**COUNTY OF SAN MATEO
PLANNING AND BUILDING DEPARTMENT**

SUBJECT: EXECUTIVE SUMMARY: Consideration of a Design Review Permit, Coastal Development Permit, Non-Conforming Use Permit, and Grading Permit, to allow construction of a new two-story, 1,590 sq. ft. single-family residence with an attached 418 sq. ft. garage and 800 sq. ft. Accessory Dwelling Unit (ADU), on a legal 4,800 sq. ft. non-conforming parcel, in the unincorporated Miramar area of San Mateo County. The use permit is required to allow development on a less than 5,000 sq. ft. parcel, where 10,000 sq. ft. is the minimum lot size in the S-94 Zoning District and to allow reduced side setbacks of 5 feet 3.5 inches where 10 feet is required. The project involves 290 c.y. of earthwork and approximately 73 feet road extension of Alto Avenue. The project is not appealable to the California Coastal Commission. In conjunction with the requested permits, it is recommended that the Planning Commission determine that the project is categorically exempt from California Environmental Quality Act (CEQA) pursuant to CEQA Guidelines Section 15303.

County File Number: PLN 2021-00101 (McGregor)

D2-0
Scale: As Noted
Sheet size: Arch D

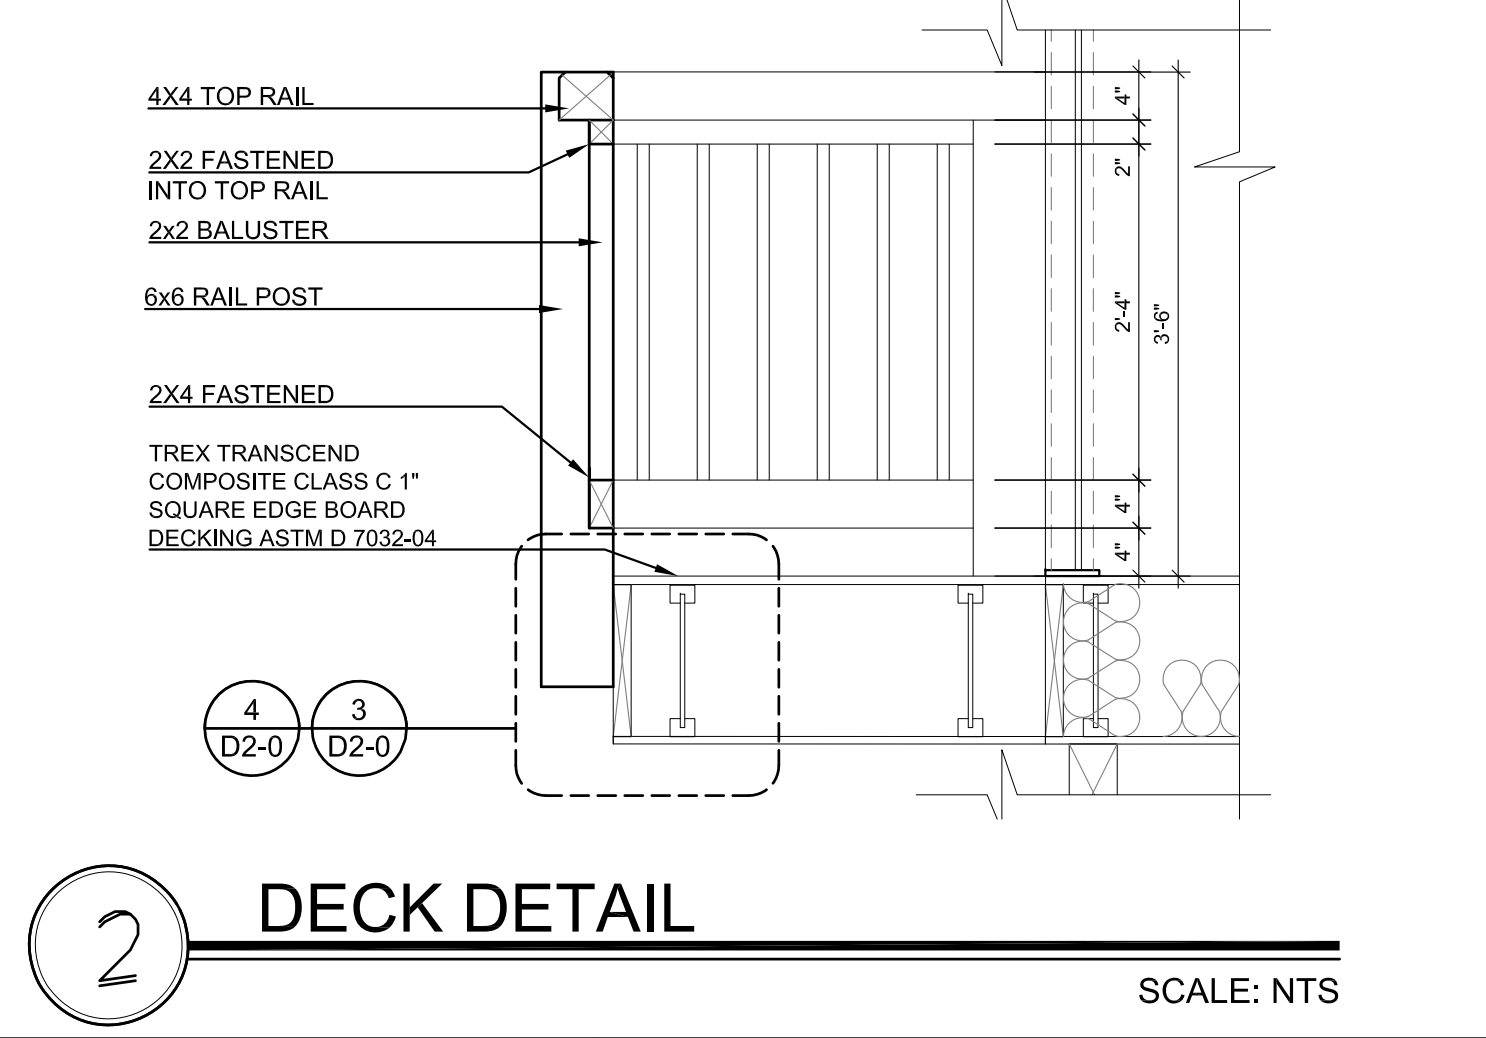
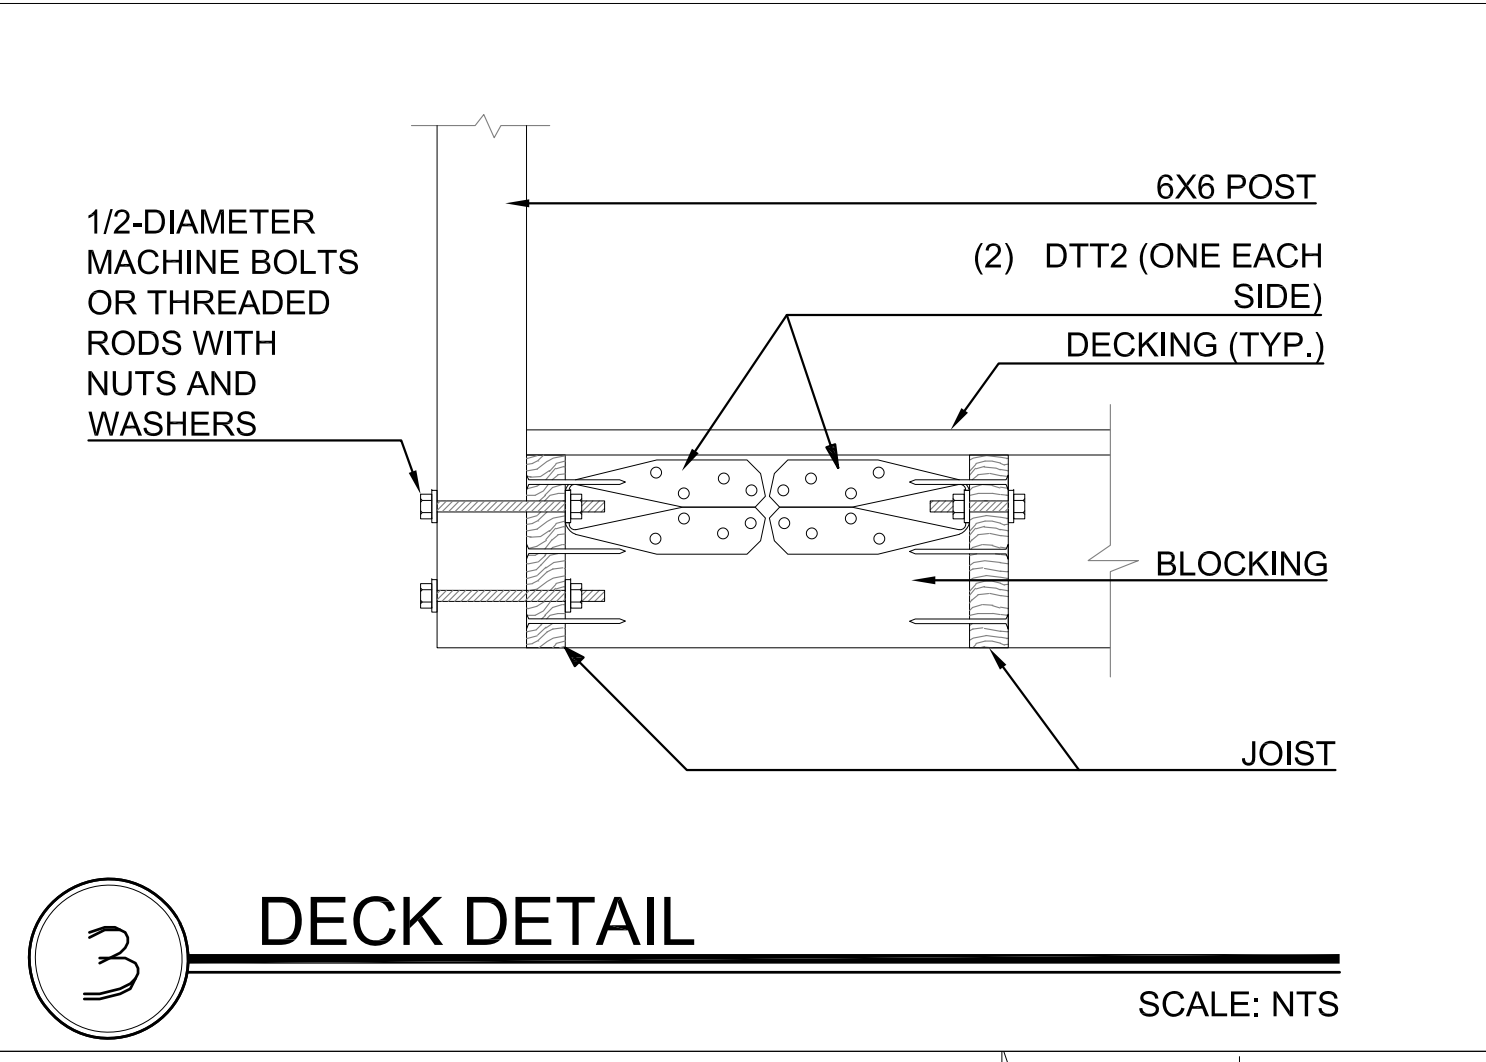
- d. Reconsider grading at rear patio to determine if guard rail is necessary. If guard rail is required, applicant shall match the specification on Sheet D2-0.
